RAMP REPORT REGION 2 ADA 2026

Lawerence St., & Ingraham Lane,
Rockland

CR16936

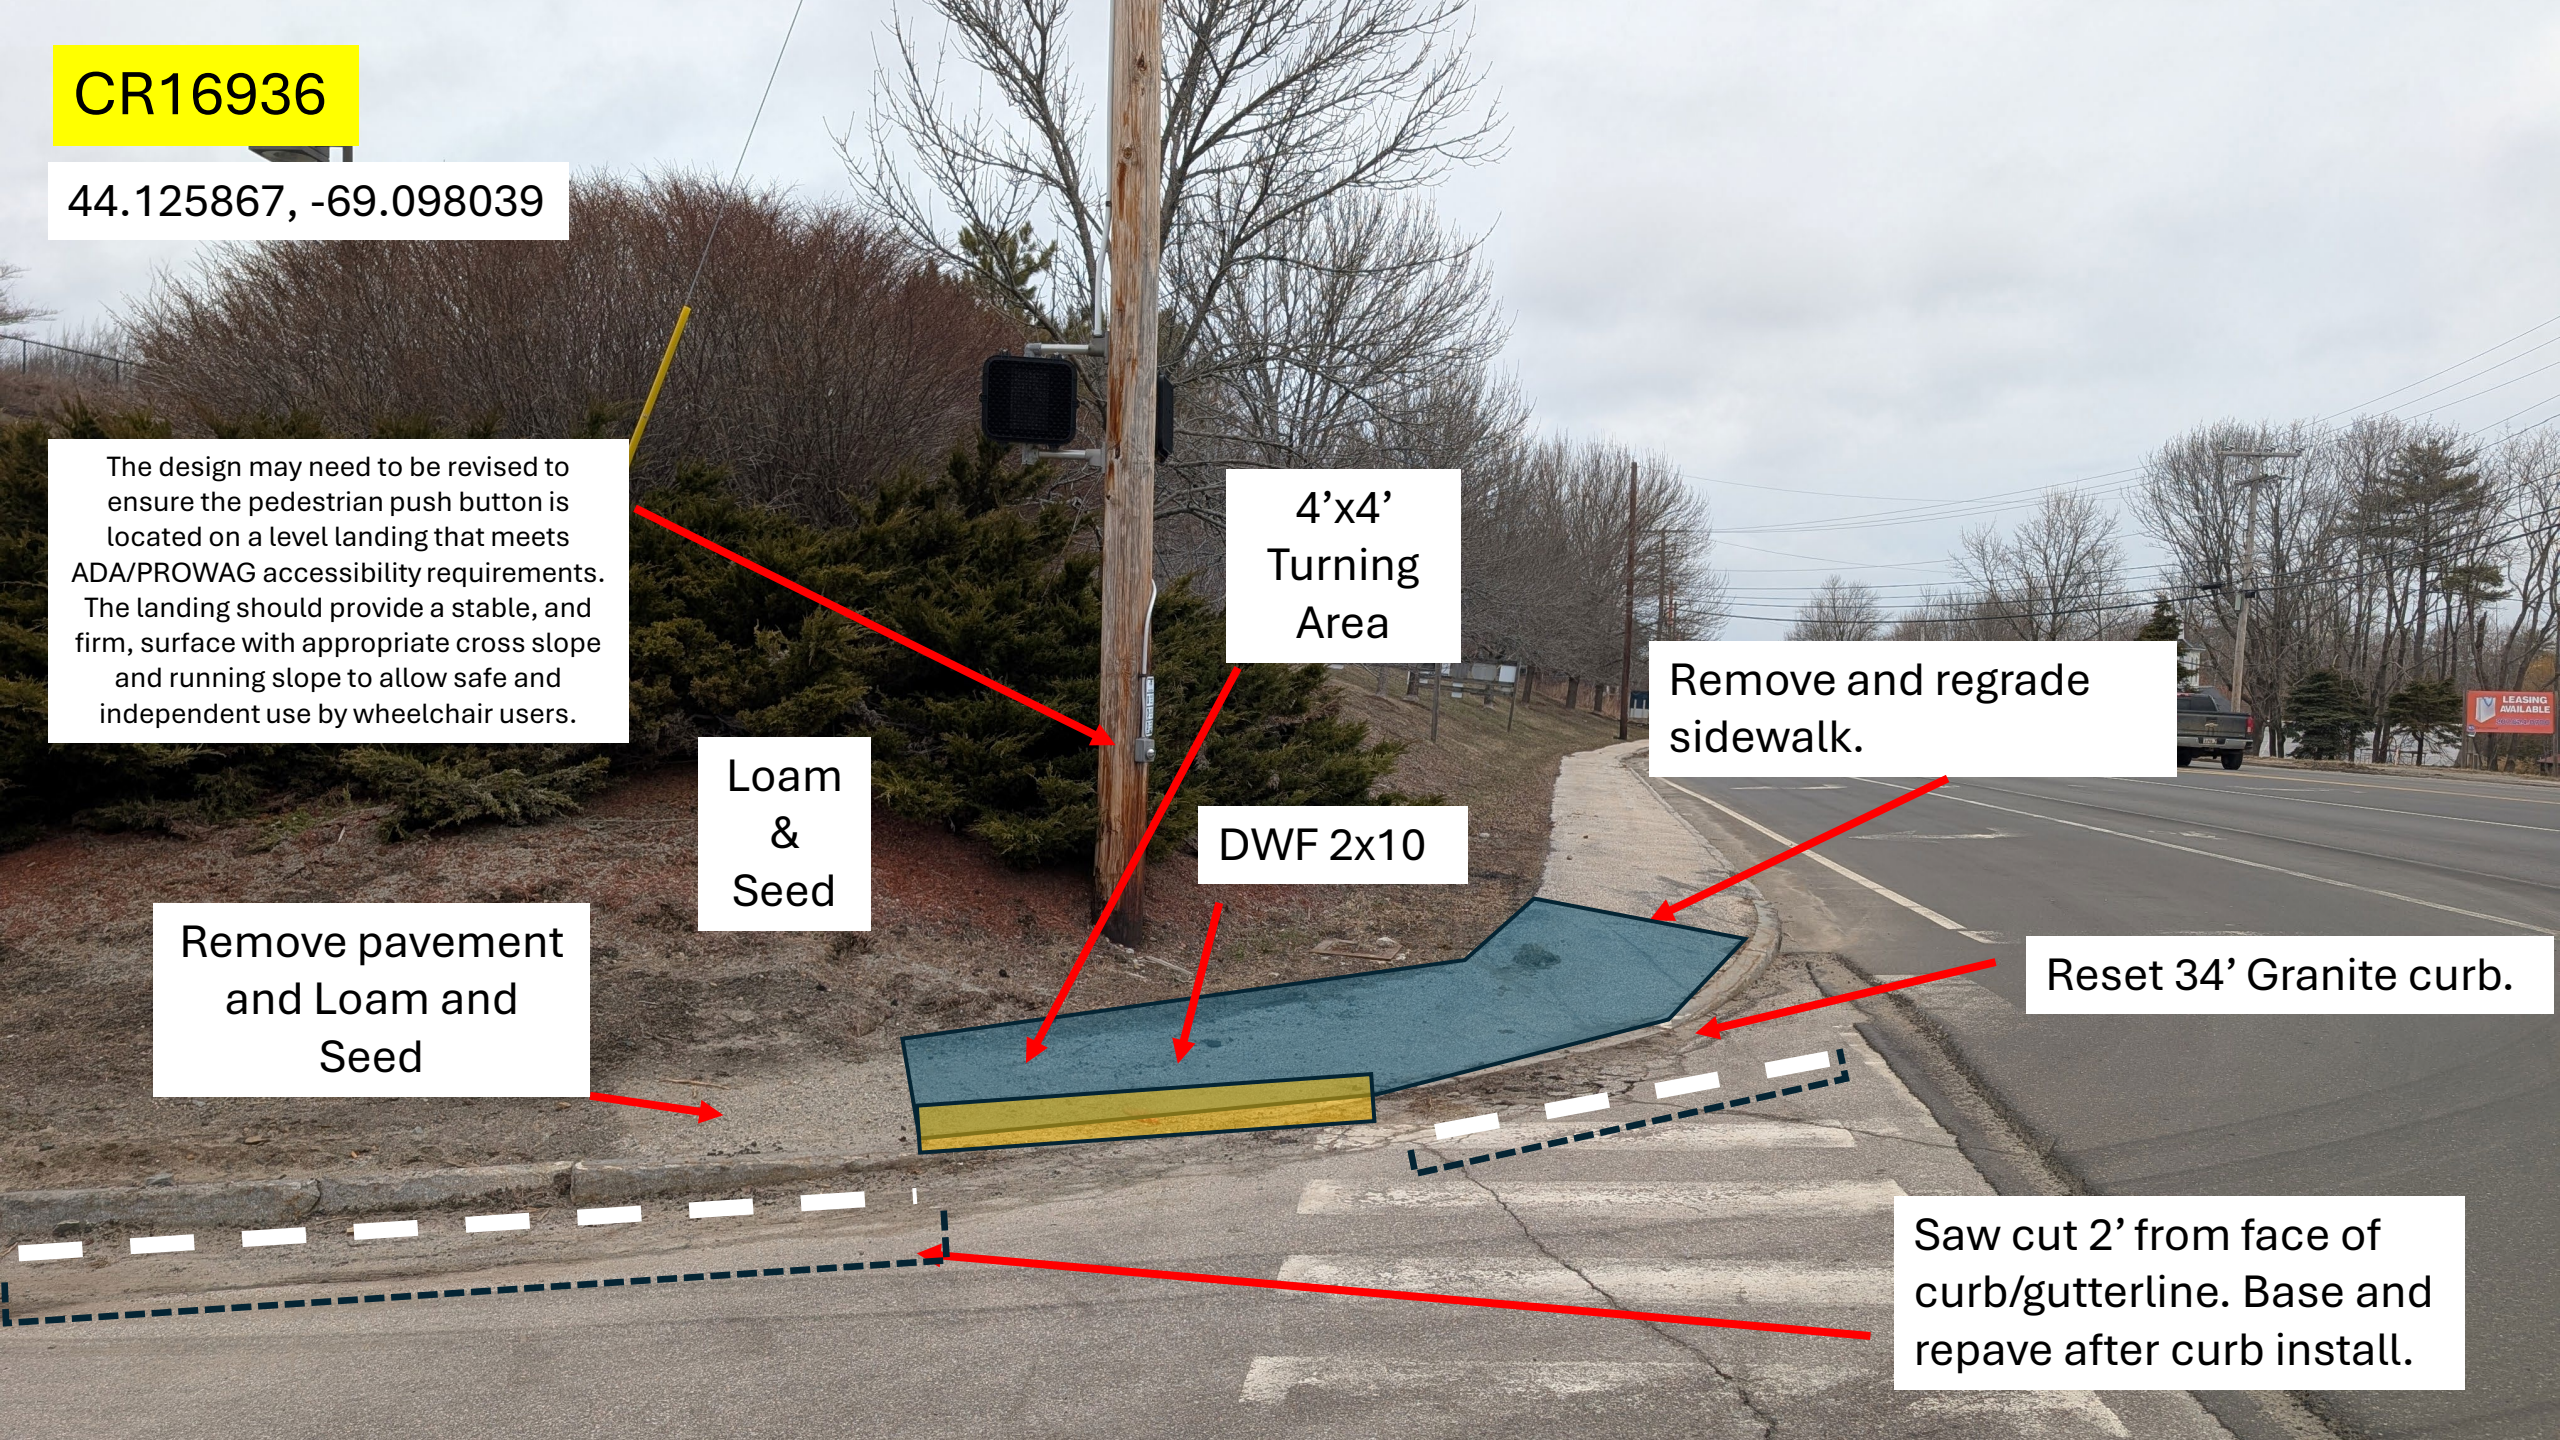
The design may need to be revised to ensure the pedestrian push button is located on a level landing that meets ADA/PROWAG accessibility requirements. The landing should provide a stable, and firm, surface with appropriate cross slope and running slope to allow safe and independent use by wheelchair users.

Loam
&
Seed

Remove pavement
and Loam and
Seed

4'x4'
Turning
Area

DWF 2x10

Remove and regrade
sidewalk.

Reset 34' Granite curb.

Saw cut 2' from face of
curb/gutterline. Base and
repave after curb install.

CR16773

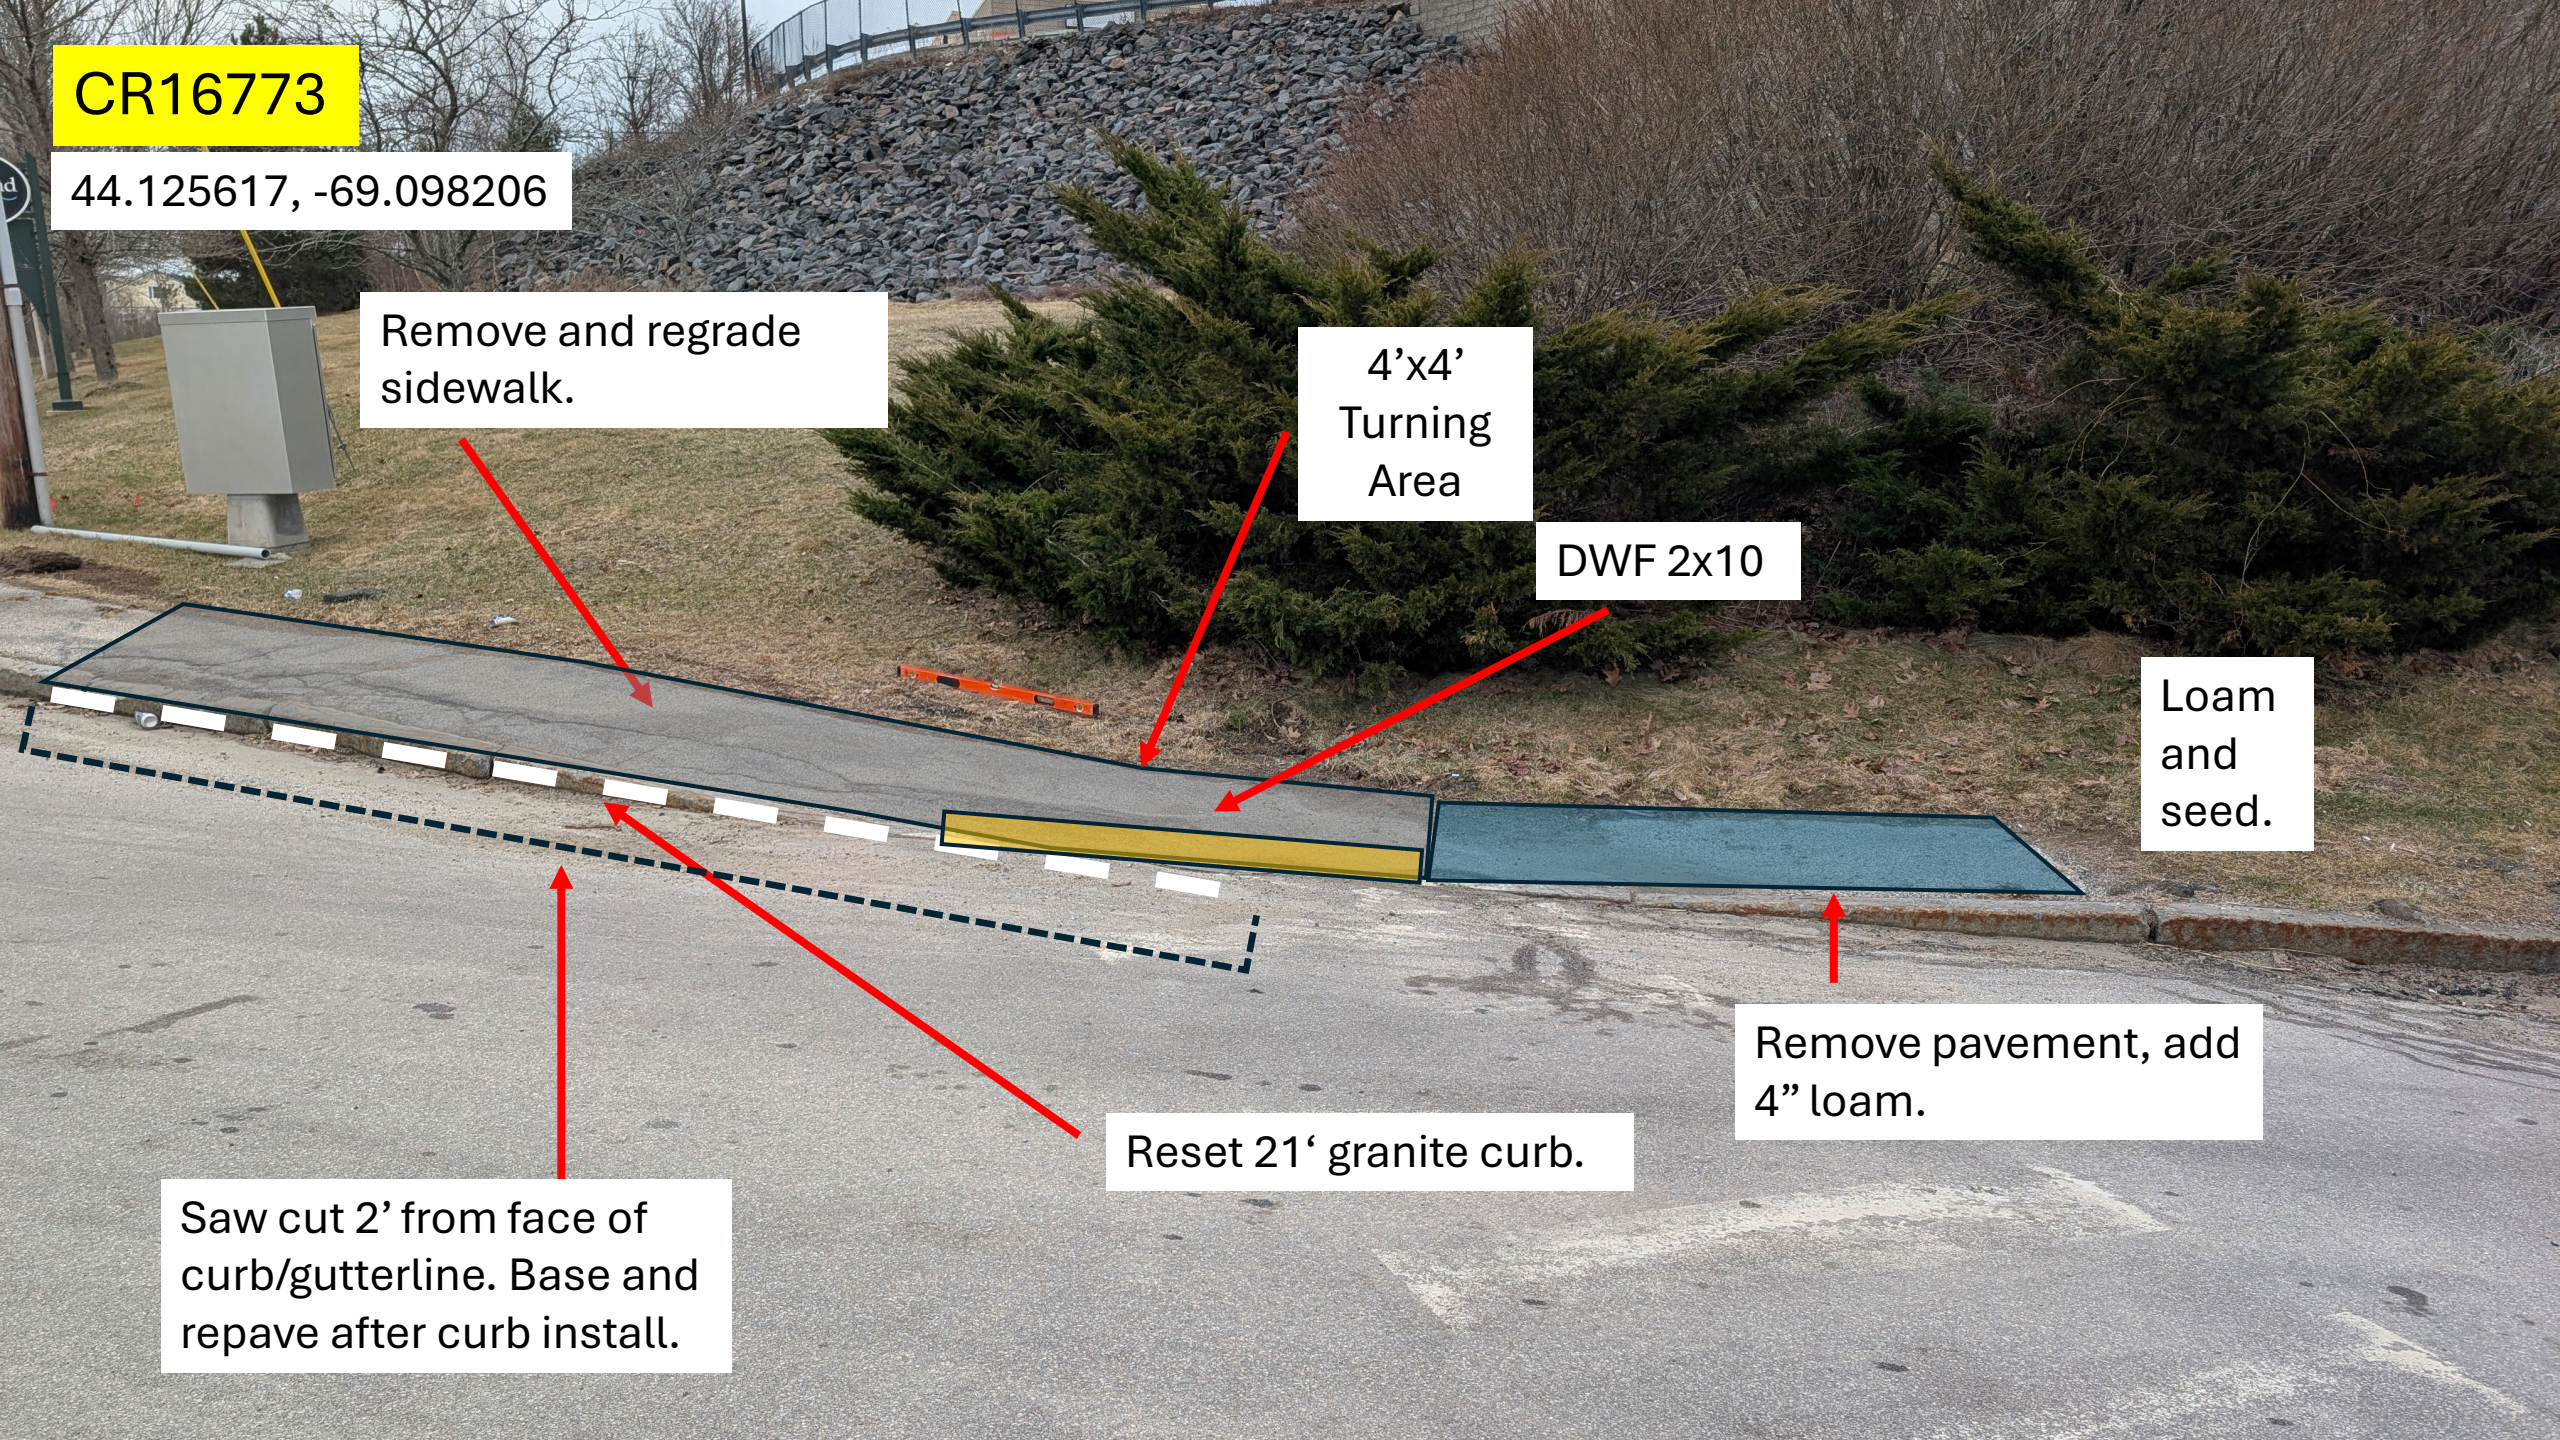
Remove and regrade
sidewalk.

4'x4'
Turning
Area

DWF 2x10

Loam
and
seed.

Remove pavement, add
4" loam.

Reset 21' granite curb.

Saw cut 2' from face of
curb/gutterline. Base and
repave after curb install.

CR16775

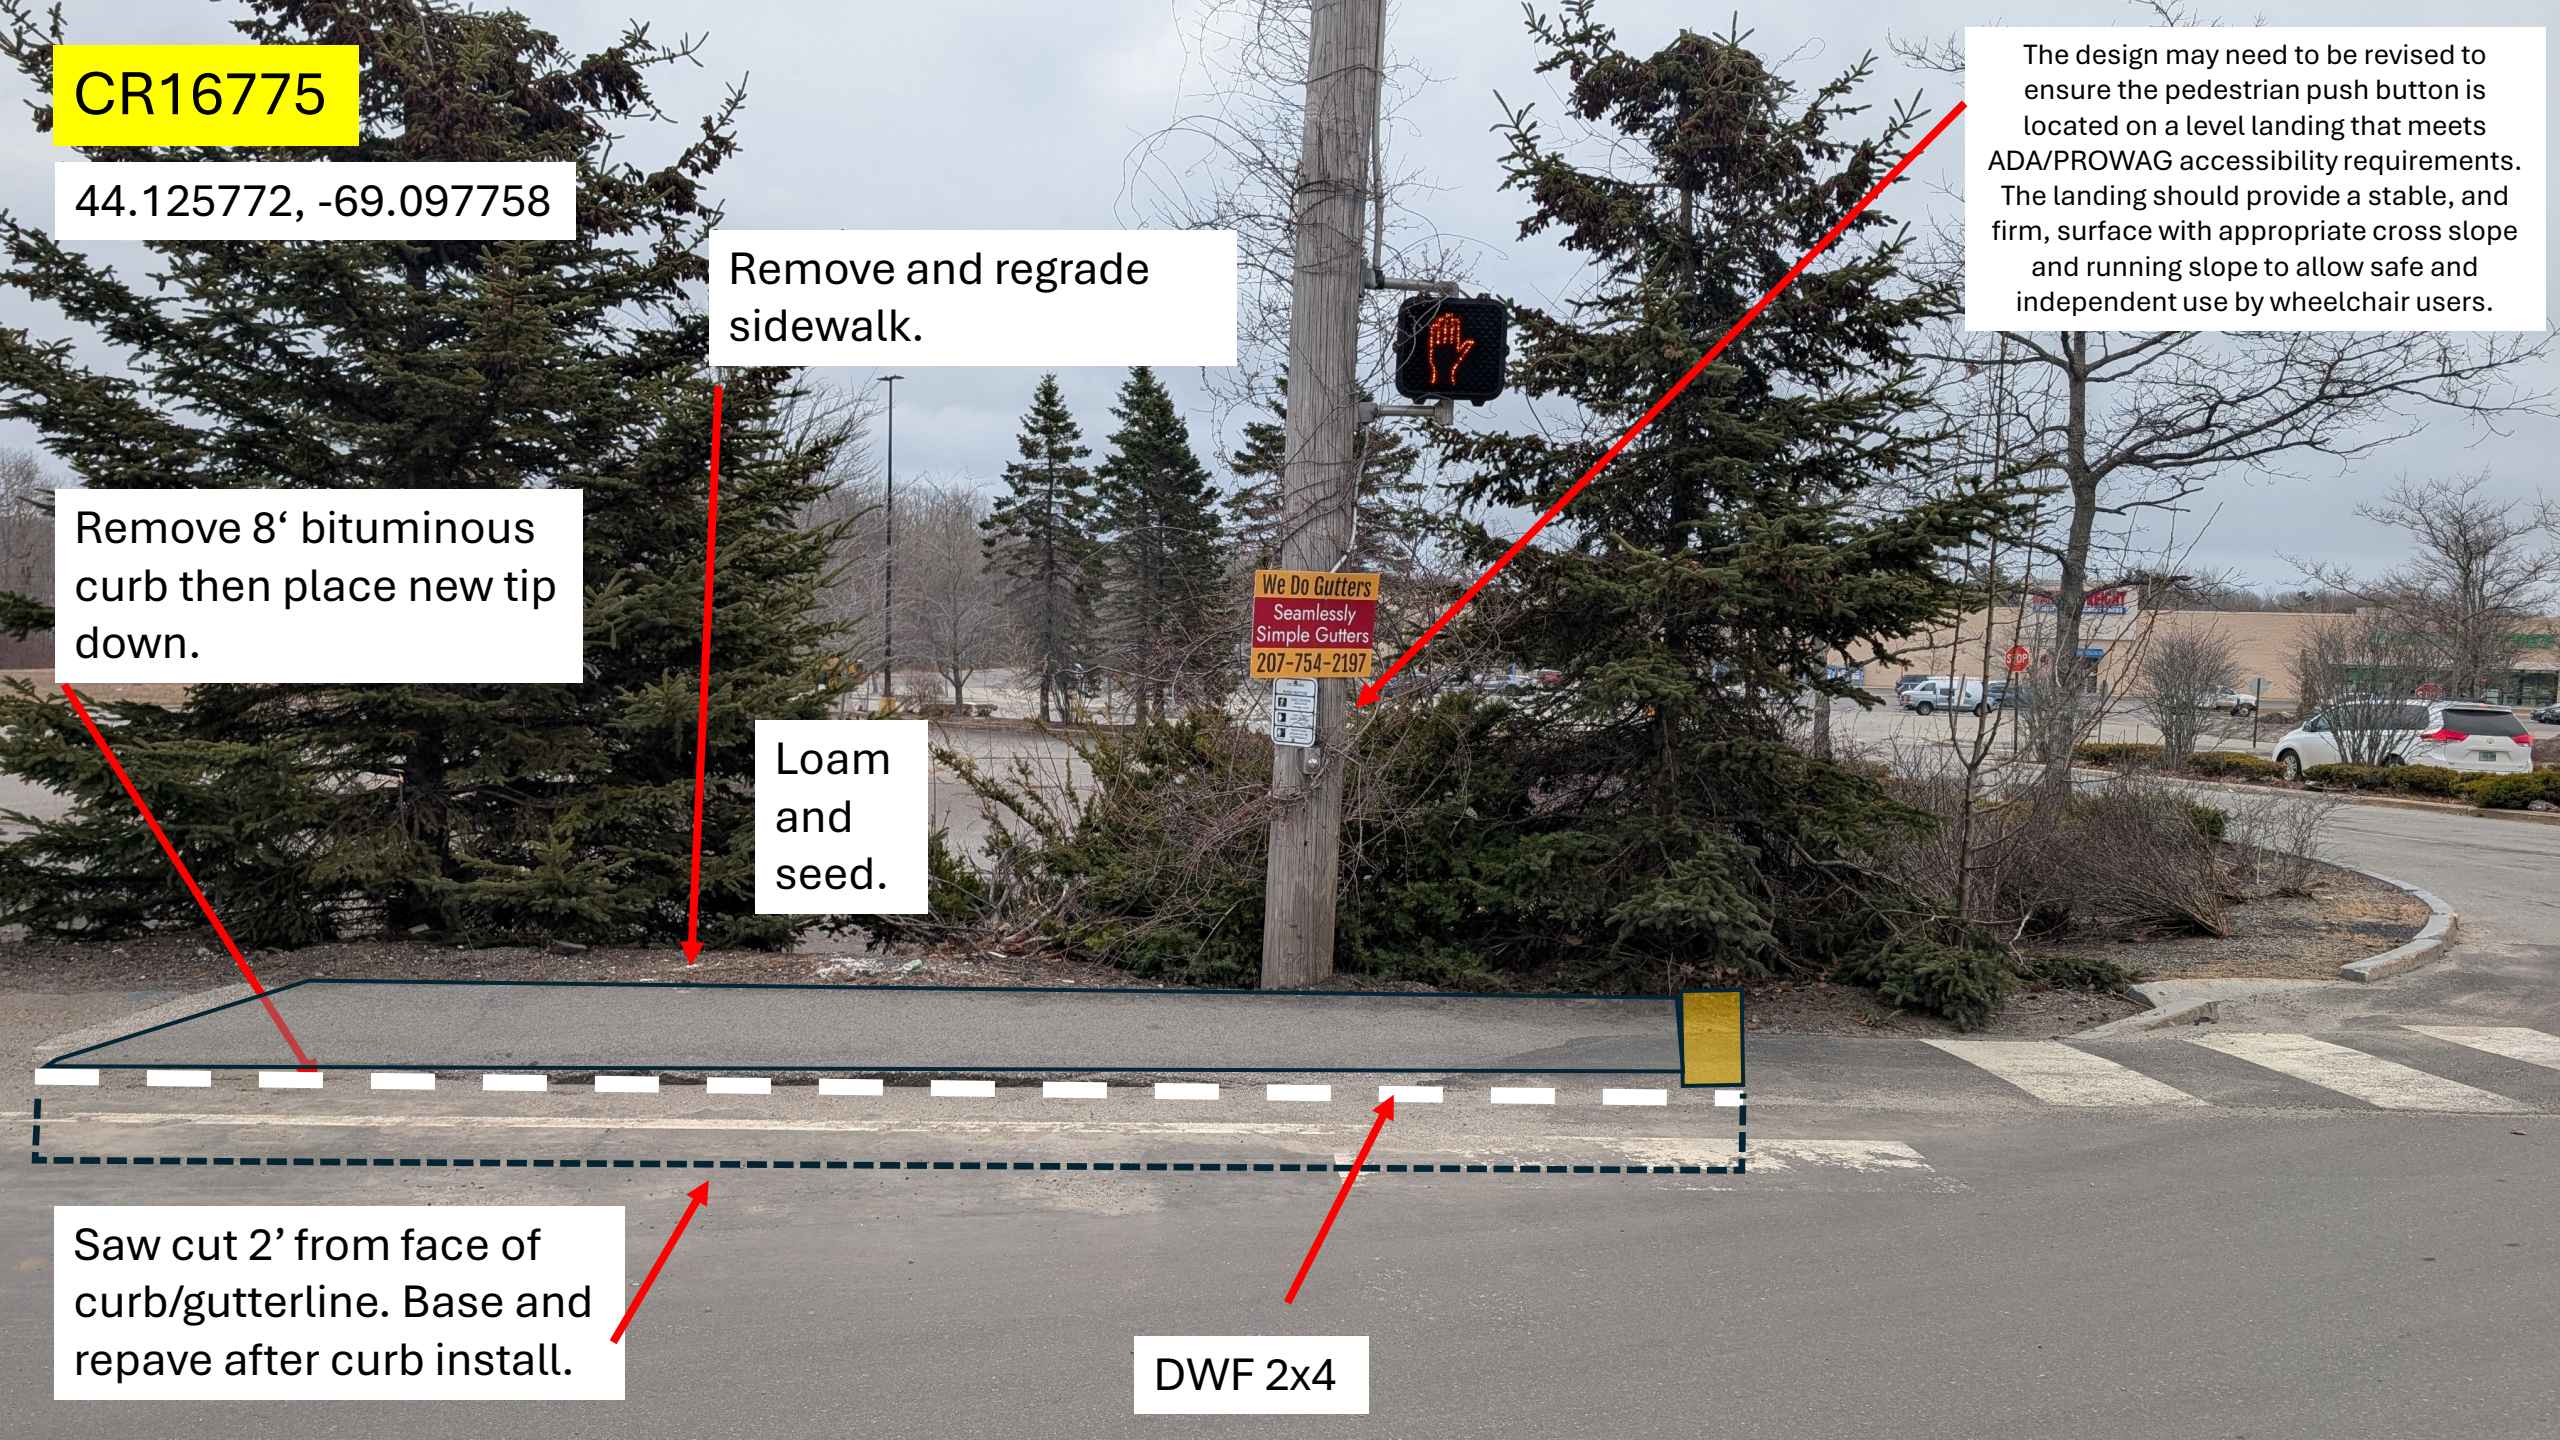
Remove and regrade
sidewalk.

Remove 8' bituminous
curb then place new tip
down.

Loam
and
seed.

Saw cut 2' from face of
curb/gutterline. Base and
repave after curb install.

DWF 2x4

The design may need to be revised to ensure the pedestrian push button is located on a level landing that meets ADA/PROWAG accessibility requirements. The landing should provide a stable, and firm, surface with appropriate cross slope and running slope to allow safe and independent use by wheelchair users.
